**New 1.5"/2" PE Series valves – Frequently Asked Questions:**

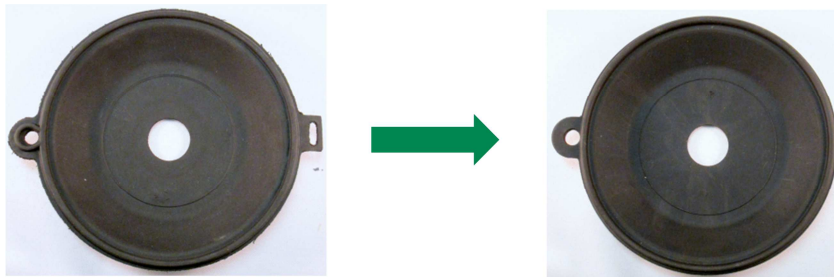
The new and old valves are easily distinguished by the appearance of the bonnets as shown below:

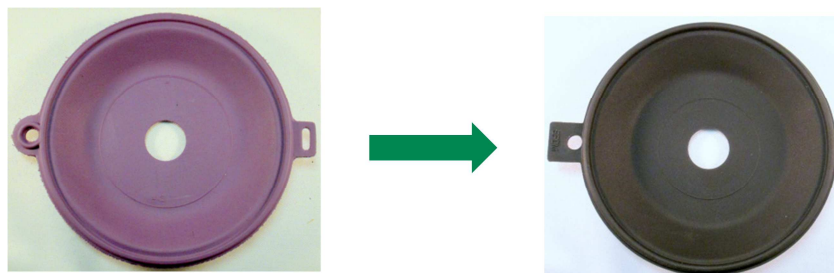
The old and new diaphragms for the PEB and PESB valves are distinguished by the absence of a rectangular tab as shown below:
